RE: Readiness Review Program
Module 13A
Foundation Materials and Backfill

VOGTLE ELECTRIC GENERATING PLANT

READINESS REVIEW

MODULE 13A - FOUNDATION MATERIALS AND BACKFILL

FIGURE 2

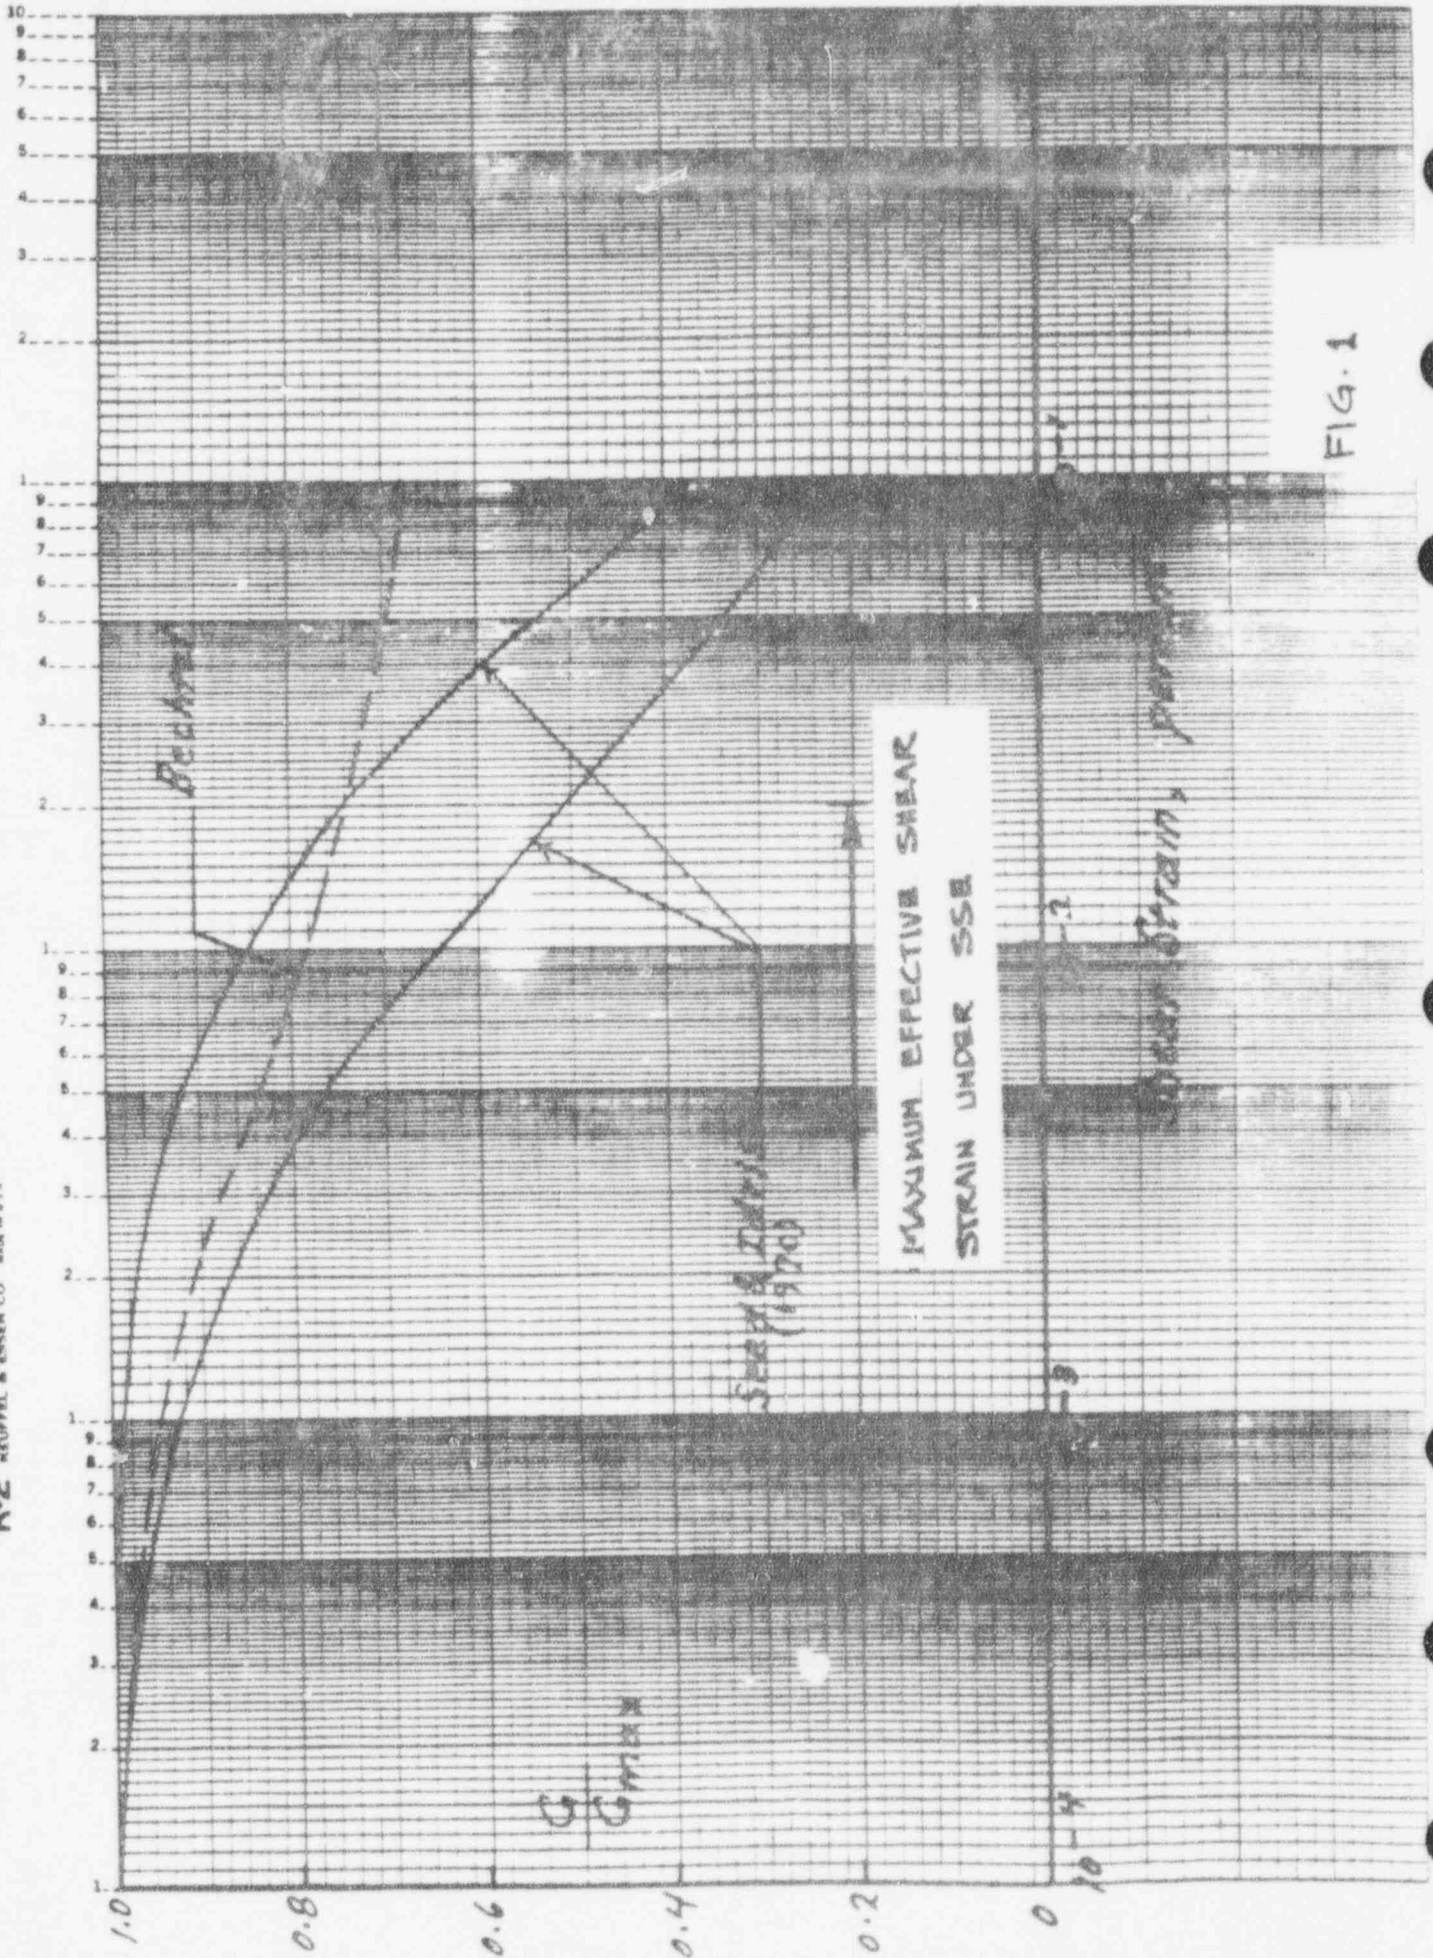
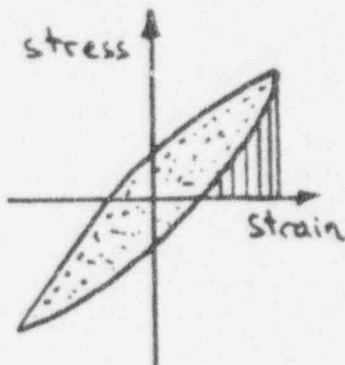
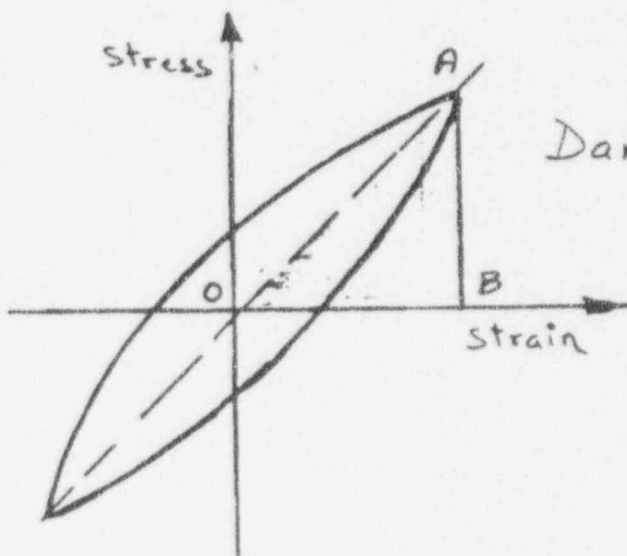
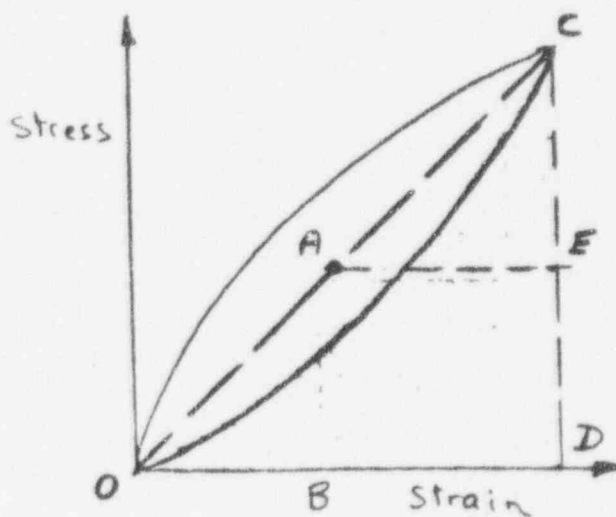
- b. The definition of damping ratio as given in Fig. 19 of the Appendix to the Bechtel Report on Dynamic Properties for Compacted Backfill differs from that referenced in the Shannon and Wilson-AJA (pg. 76) report. An explanation for the use of the alternate method of determining the damping ratio should be included.

- b. Specific Damping Capacity is defined as the ratio of the energy absorbed in one cycle of vibration to the potential energy at maximum displacement during that cycle, or, with reference to Figure 2a:

For an isotropic cyclic test, this definition becomes (See Shannon and Wilson Report and Figure 2b):

For an anisotropic cyclic test, this definition becomes (See Figure 19 of Appendix to Reference 3 and Figure 2c):

Performing the cyclic triaxial test using compression loading only might have resulted, if any, in lowering the material damping values, which is conservative. In addition, in the strain range greater than $10^{-2}\%$, for which the triaxial test was utilized, the project damping curve falls below the Seed and Idriss curve (Figure 10 of Reference 2) and is within the band recommended by them.

- B. The definition of damping ratio used for these tests was clarified by demonstrating that the geometry used for an anisotropic test was similar to that used for an isotropic test. This response satisfies the IDR team concern.
